**Re: Leaside Shopping Centres Limited  
Item PG18.5 – Proposed Technical Amendments to By-law 569-2013**

**RE: Amendments to By-law 569-2013 (Section 200.15)**

Proposed Adjustments to Accessible Parking Spaces  
Submitted to the Planning & Growth Management Committee

Figure 1

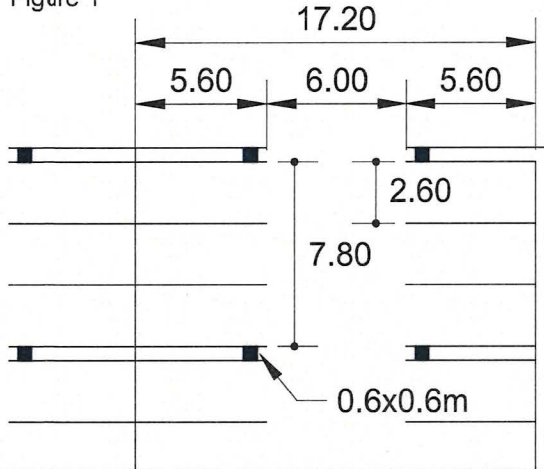
The impact to development of the proposed change is significant. The current width of 3 City of Toronto parking spaces (the typical number of spaces that fit within a typical structural grid in an above- or below-grade parking structure) is 7.8m plus the width of adjacent columns (Figure 1). Three typical spaces can be replaced with 2 AODA-compliant accessible parking spaces (3.4m "Type A" + 1.5m aisle + 2.4m "Type B" = 7.3m, Figure 2). Replacing 3 typical spaces with 2 proposal-compliant accessible spaces results in a required width of 8.3m (Figure 3). This exceeds the typical structural grid used in above- or below-grade parking facilities and may require structural changes near accessible spaces.

Our recommendation would be to adopt the sharing rules (between Type A and Type B spaces) as set out in the AODA and to adjust the length requirement to 5.6m so as to be compliant with the AODA and to be compatible with other critical zoning by-law parking dimensions.

Figure 4

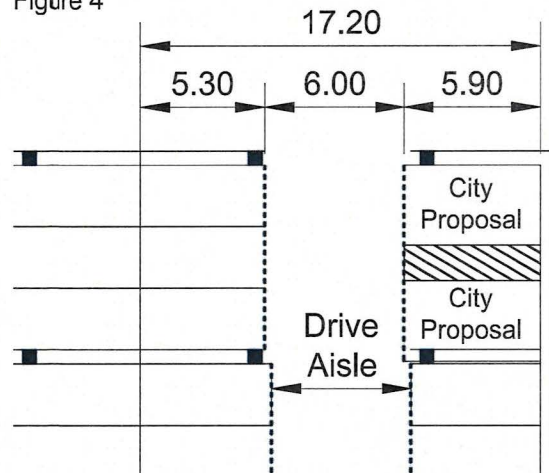
- 1) Drivers, travelling down the drive aisle, would see the 6.0m aisle "jog" to the side as they travelled, resulting in a less safe condition within the parking area (Figure 4).
- 2) Parking spaces opposite the barrier free spaces may become shorter (5.3m in length) which would require by-law relief (Figure 4). Without relief all parking spaces within the impacted zone would be forced to shift (with parking spaces also shifting the entirety of the parking area) or resulting in the creation of unusable space within the parking area (Figure 5).
- 3) If structural grids could not be adjusted to accommodate the shifts required by the longer spaces, some parking spaces might violate the City's "obstruction rule" within the By-law (200.5.1.10 (D)), resulting in the need to seek relief from the rule through a variance or Site Specific By-law (Figure 6).
